SUBJECT: COMANCHE PEAK NUCLEAR POWER PLANT, UNITS 3 AND 4
DOCKET NUMBERS 52-034 AND 52-035
COMBINED LICENSE APPLICATION PART 10 REVISION 3, UPDATE TRACKING
REPORT REVISION 1

**Comanche Peak Nuclear Power Plant, Units 3 & 4
COL Application**

**ITAAC and Proposed License Conditions
Revision 3**

Update Tracking Report

**Figure A.3-1 (Sheet 1 of 2) General Arrangement Plan of UHSRS, ESWPT, and PSFSV
Identifying Internal Flood Barriers**

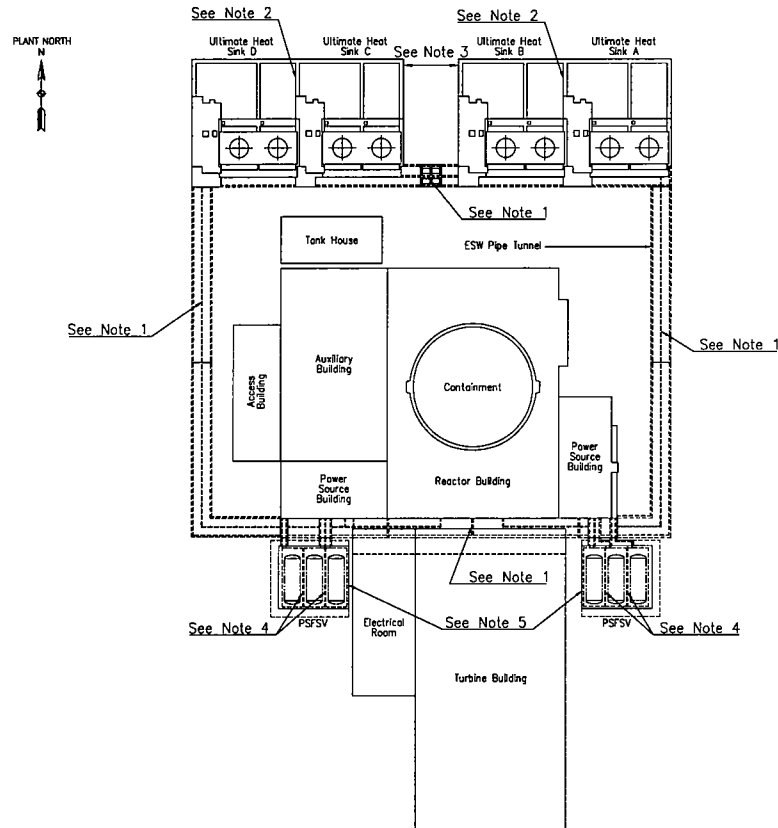
Change ID No.	Section	ITAAC Rev.3 Page *	Reason for change	Change Summary	Rev. of T/R
CTS-01511	Appendix A.3 Table A.3-1	35, 36, 37 [38]	To reflect updates on the Technical Report MUAP-10006(Rev3)	The wording in the title of the ITAAC Table A.3-1 is changed replacing "USHRS, ESPWT and PSFSV" with "Plant specific structures".	1
CTS-01512	Appendix A3 Table A3-2 (sheet 1, 2, 3 [4])	38, 39 and 40 [41, 42]	To reflect changes in Plot Plan and AIA.	Floor elevations and wall thicknesses revised.	1
CTS-01512	Appendix A.3 Figure A.3-1 [Sheet 1 and 2 of 2]	41 [43, 44]	To reflect changes in Plot plan	Overall General Arrangement plan replaced with the updated version; and minor editorial correction.	1

CTS-01512
